A G E N D A DESIGN REVIEW COMMITTEE

STAFF REPORT AND FINDINGS OF FACT

SUBJECT: DESIGN REVIEW REQUEST (DR13-03) BY DOUBLE R PRODUCTS FOR

SIGNAGE AT 2264 MARINE DRIVE

Existing 5' height clearance to lowest bar

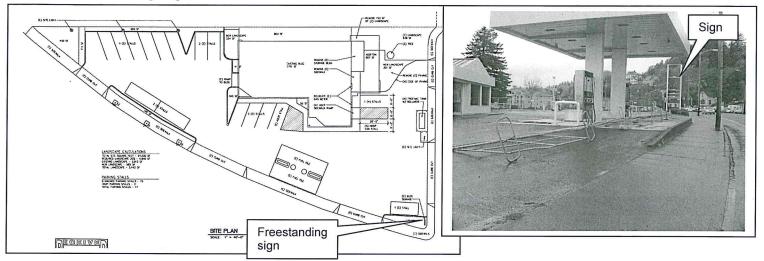
<u>Finding</u>: The applicant proposes to install signage on an existing pole mounted freestanding sign, which is discouraged within the Gateway area.

The existing freestanding sign was installed in 1997 and does not meet the current regulations for signs in the LS Zone. Freestanding signs are discouraged in this Zone and monument signs are encouraged. However, to replace the sign would be costly, so the applicant has submitted a request to retain the freestanding sign.

An allowable monument sign at this location would create a visibility issue at the 23rd and Marine Drive intersection, therefore a freestanding sign with open area below would be safer. The clear vision area for corners states that there should be a clear sight line from 2.5' to 8' above ground at the corner. This sign would allow a clear line of sight from 2.5' to 6.5' above grade. Engineering Tech Dean Zeisbrich indicates that the existing lowest bar is at approximately 5' and the increase to 6.5' would allow sufficient visibility. The City Engineer has reviewed the proposed retention of the existing sign location and stated that the previous 5' clearance did not meet the standards, but did provide better vision opportunities than a solid monument sign would. He stated that if the vision clearance area is reduced that the sign should be relocated or the sign reconfigured to provide adequate sight distance. The applicant proposes to increase the existing 5' clearance to 6.5' clearance to provide better sight distance. With the condition that the lowest bar allow a clearance of approximately 6.5', the sign would not interfere with the existing traffic visibility.

Use of the existing freestanding sign structure at a height of 16.6' with visibility through the bottom of the sign would be acceptable at this location.

- 1. Only the gas pricing area of the sign which includes the price and lettering for the grade of gas may be internally lit.
- 2. The lowest bar of the freestanding sign shall maintain a clearance of approximately 6.5'
- 3. The applicant shall contact ODOT to verify compliance with the ORS requirements and the ODOT Outdoor Advertising Sign Program.
- 4. The applicant shall obtain Variance approval for the proposed signage.

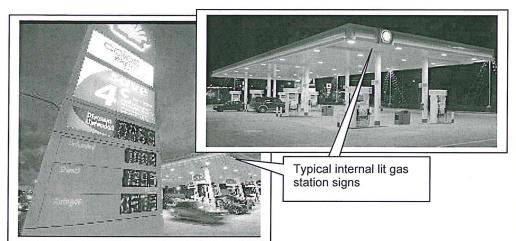
<u>Finding</u>: The applicant proposes to install an internal lit LED gas pricing sign on the freestanding sign structure, which is discouraged within the Gateway area.

The building is located on a curve on Marine Drive with limited visibility of various portions of the building due to the architecture of the building with the gas canopy and central portion that extends out beyond the front plane of the rest of the building. The proposed signs on the canopy (Signs 2a and 2b) and freestanding sign (Sign 1) are the minimal allowed by the corporate requirements for a Shell gas station. Generally these signs are internal lit cabinets and gas pricing signs are generally now internal lit LED signs. The applicant has eliminated the back lit cabinet signs originally proposed for the canopy and freestanding sign. The striping on the canopy would be painted on the canopy and not internal lit. Only the gas pricing would be lit. Other portions of the signage would be a plastic cabinet but there would be no internal illumination. The gas pricing would be static and would not flash or scroll.

The grade of the gas (Regular, Plus, V-Power) would be back lit. Only the letters should be backlit and not the entire panel.

The Gateway Area is intended to have signs that are more reflective of the character of the Uppertown historic neighborhood and there are concerns that the use of fully internal lit cabinets are not compatible with this design goal. As new development occurs and older signs are removed, the intent was for the reduction of internal lit cabinets in this area. Staff would note that the use of an internally lit sign for the gas pricing may be necessary due to the nature of the industry and the need for easy change of the prices on a regular basis. In order to address the needs of the gas pricing while balancing with the goals of the district, staff recommends that the sign have the internal lit LED gas pricing but that no other signs may be internally lit.
